2.0 KEY FEATURES AND FINDINGS

2.3 PUD ZONING PLAN CONDITIONS OF APPROVAL

The following conditions were placed upon the Haymeadow PUD Zoning Plan as approved by the Town of Eagle Board of Trustees on October 23, 2012. This section of the application addresses the PUD Development Plan response to each of the conditions placed upon the Zoning Plan application. A copy of the PUD Zoning Plan is attached at the end of this chapter.

Figure 1. Developing Plan, Existing Vegetation Types & Riparian Enhancement Areas Haymeadow Project

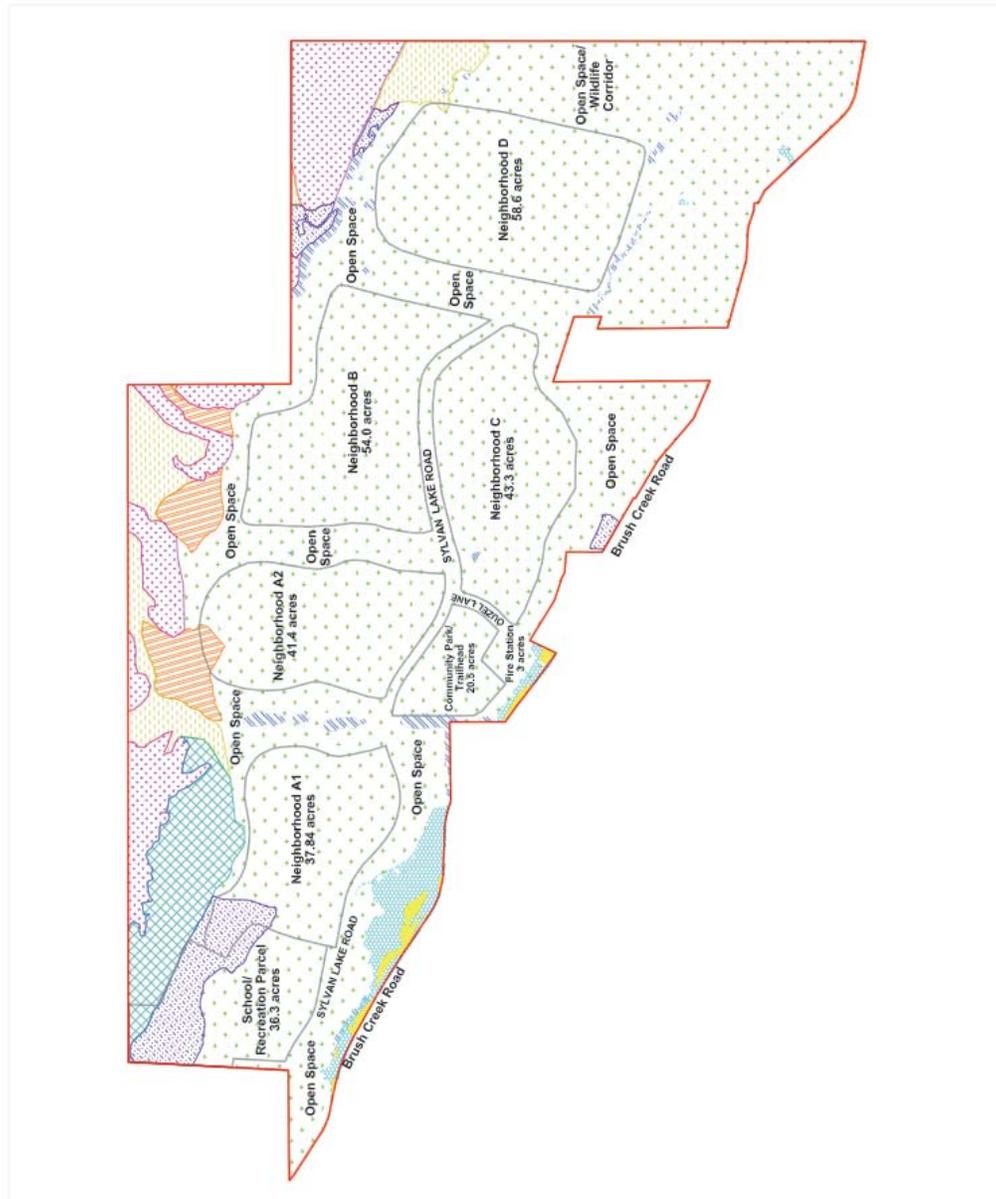
- 3. The first Preliminary Subdivision Plan application shall include a plan to enhance wetland and riparian areas of the property. The addition of trees, bushes and vegetation at appropriate locations should be part of this plan. Given the location of these wetlands and riparian areas along Brush Creek Road, there is the potential for this vegetation to not only**

add to the wildlife value of this area but also provide a more attractive environment and screening along Brush Creek Road.

The Haymeadow project team ecologist and wetlands consultant has reviewed this condition and conducted a site visit to assess potential wetland enhancements. The ecologist's assessment and a description of how wetland enhancement could be designed are attached the end of this section of the application. The assessment includes a narrative description, a table of recommended plant species and a site plan indicating potential enhancement areas. The described wetland enhancements will be fully designed and completed as a part of the Trailhead Park construction plans. This condition should now be carried forward to final plat to ensure integration of these enhancements into the park construction plans.

Per your request, I am providing recommendations for enhancing the existing wetlands near Brush Creek Road with native riparian species in order to improve habitat quality, aesthetics, and screening from the road. As you know, I recently remapped the wetlands on the Haymeadow project site in July 2013. The updated wetland boundary is illustrated on the attached Figure 1. In addition, the Figure identifies eight proposed Riparian Enhancement Areas adjacent to the wetlands. The eight areas comprise approximately 2.36 acres of the project site; all are located in upland habitats that are currently planned for open space.

Table 1 provides a list of recommended native plant species for use in these areas. The list was developed based on my observations on the project site and my experience delineating wetlands in the Brush Creek Valley. These species are appropriate for the wetland types that occur on the project site and they can all be found nearby along the Brush Creek riparian corridor. Once established, these native species should not need supplemental irrigation; however it may be required during the initial establishment period.

Within the proposed Riparian Enhancement Areas, I recommend creating small, scattered clusters of trees and shrubs. The size and spacing can be adjusted based on your budget and requirements. As you know, cuttings can be created from willows, which is a very cost-effective way to establish new stands. For the cottonwood trees and other shrubs, I recommend purchasing nursery-grown stock. I generally have the best luck with cottonwoods that have about a 1-inch caliper trunk size. For most of the shrubs, I recommend five-gallon sized pots because smaller sizes can often be difficult to establish where there is already tall, dense vegetation. In my experience, it is better to plant fewer, larger sized shrubs where the establishment rate is higher than to spend the same money on a many smaller plants, where survival is typically reduced.
